BIF-107-50117-68

Subject: Trip Report - FAMS Light
Location Review at EK

A meeting was held at the EK facility 13 August 1968 to review the Fams light location and interface implications. Attendees from Aerospace were S. Brewer and L. Watson. EK personnel included R. Keim.

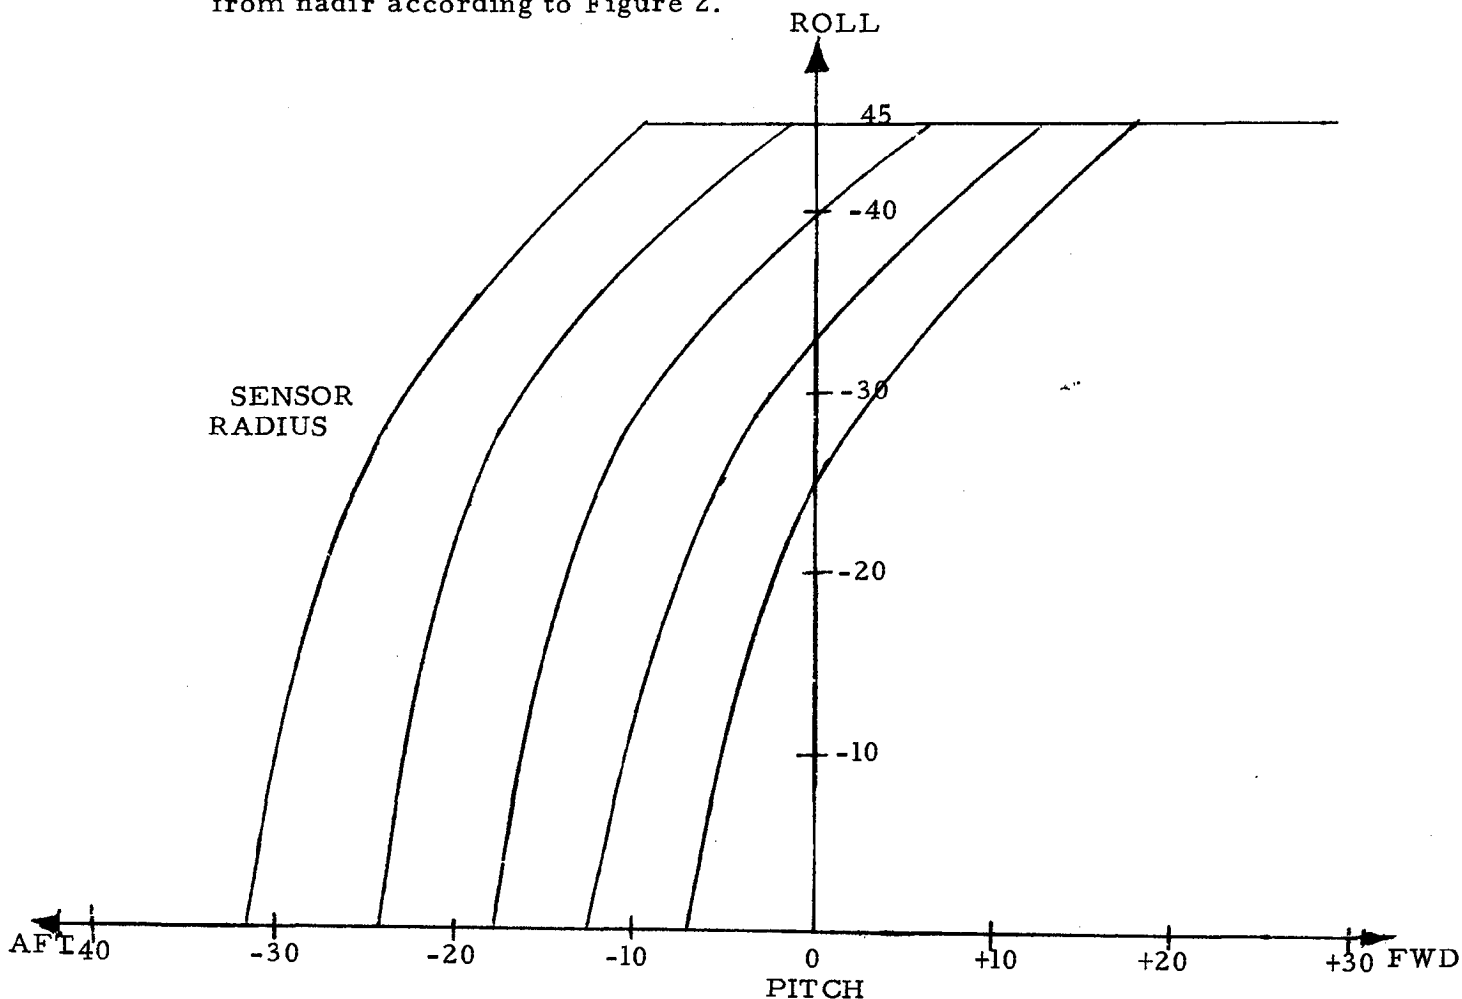
Three possible locations for the FAMS light were discussed. These are designated A, X₁, X₂ as shown in the following sketch of the Ross Barrel.

Tentatively GE is considering the sensor location at station "500" with the sensor center at a position 52 inches below the MM center line. They have indicated to EK that the sensor requires a three-inch diameter light beam for adequate coverage at the sensor plane. It is estimated that an additional 1.5 inches in diameter overlap will be required to take into account sensor light line-of-sight uncertainties due to air bag/launch lock differences, assembly tolerances, handling variations, on-orbit zero-G effects, thermal effects, etc. Therefore, a beam diameter of approximately 4.5 inches

With the FAMS light located at position A the lower portion of the beam is limited by the bottom of the Newtonian folding mirror. With the light at X_1 or X_2 the lower portion of the beam is limited

by the protrusion of a supporting bracket structure for the invar spacer rods. The light coverage at station "500" is essentially uniform as follows.
